SUBJECT: DEPARTMENT OF THE ARMY PERMIT Number NAN-2012-00090
Originally Issued to New York State Thruway Authority on 25 April 2013 Authorizing Regulated Work to Facilitate Construction of The New NY Bridge in the Hudson River between Tarrytown and Nyack, New York

SUBJECT: Modification to Department of the Army Permit Number NAN-2012-00090 Issued to the New York State Thruway Authority (New NY Bridge Project)

6. This modified permit shall be known as Permit Number NAN-2012-00090-M6.

SECTION 8-8
ROCK OUTLET PROTECTION DETAIL

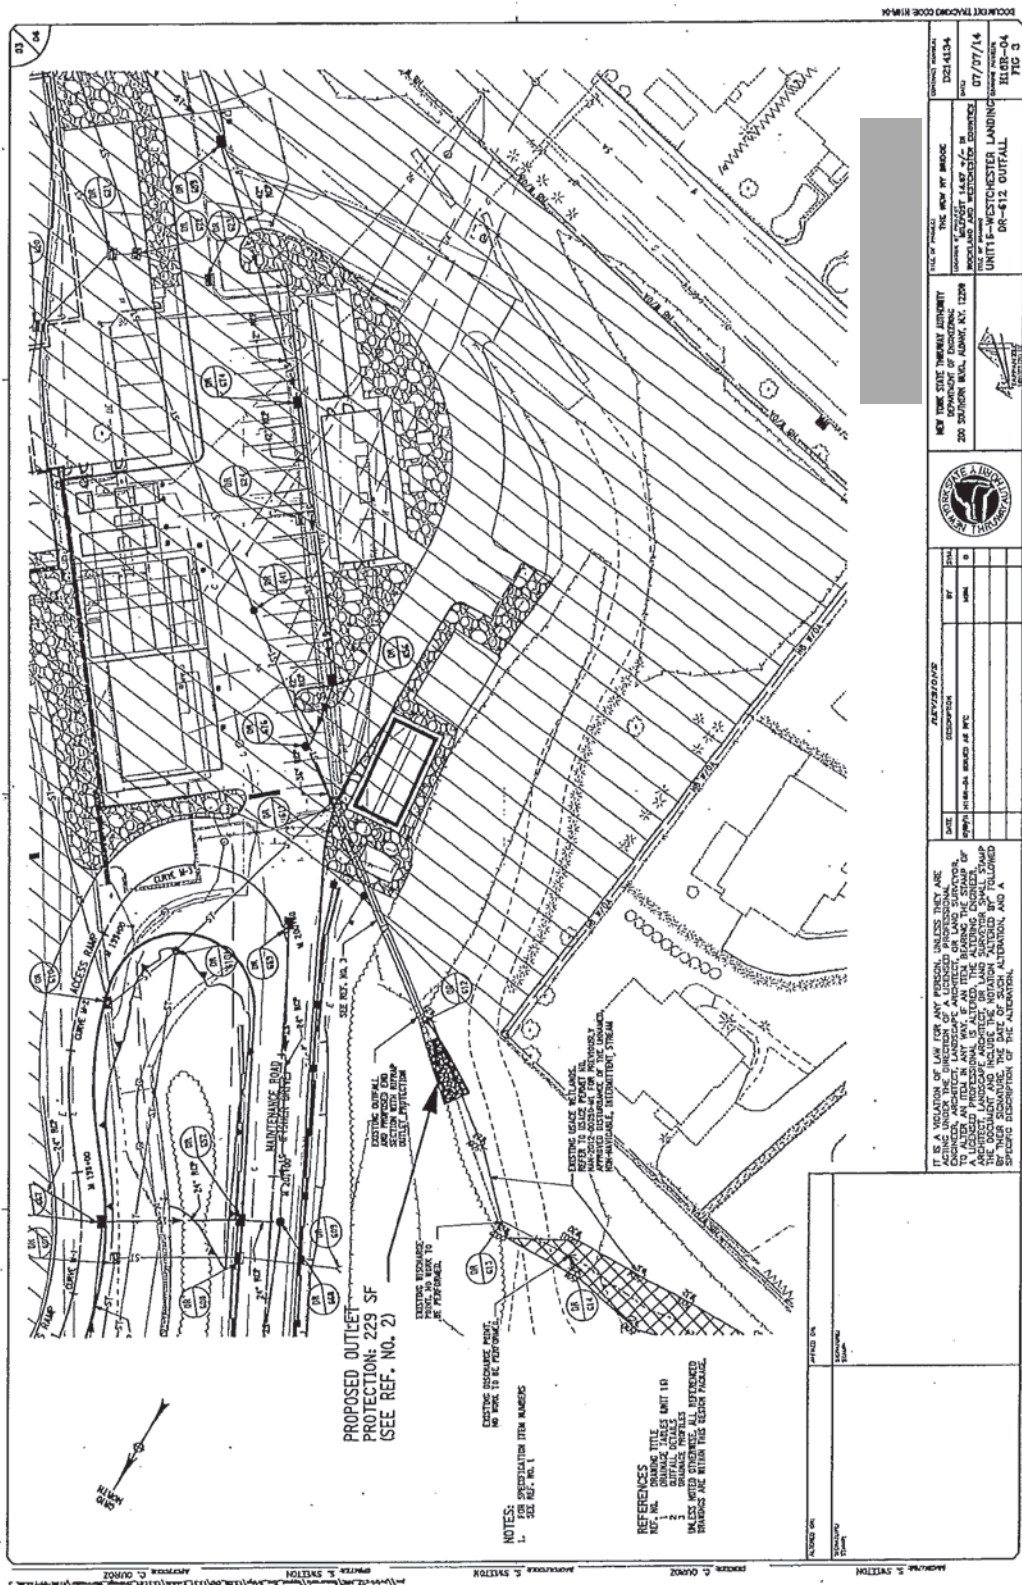
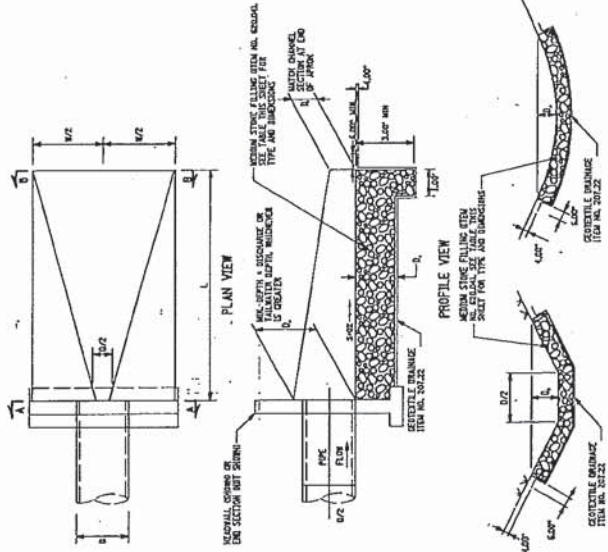
3. The modified regulated work requested at this time includes the reconstruction of the existing outfall DR-612 (a 36-inch Reinforced Concrete Pipe [RCP]) with a new concrete end section and stone rip-rap outlet protection. The proposed stone fill for DR-612 will impact approximately 229 square feet (SF) of stream bed below the ordinary high water mark (OHWM) of an unnamed non-navigable intermittent stream. Approximately 19.08 cubic yards (CY) of stone (27-inch thickness) will be discharged below the OHWM of the stream.

In addition, the proposed regulated work includes the construction of a new 36-inch RCP outfall, DR-666, with an end section and stone rip-rap outlet protection. The proposed stone fill for DR-666 will impact approximately 207 SF of federally regulated wetlands. Approximately 13.42 CY of stone (21-inch thickness) will be discharged into the wetland. Outfall DR-666 will convey stormwater from a Micro-pool Extended Detention Pond into the existing wetlands.
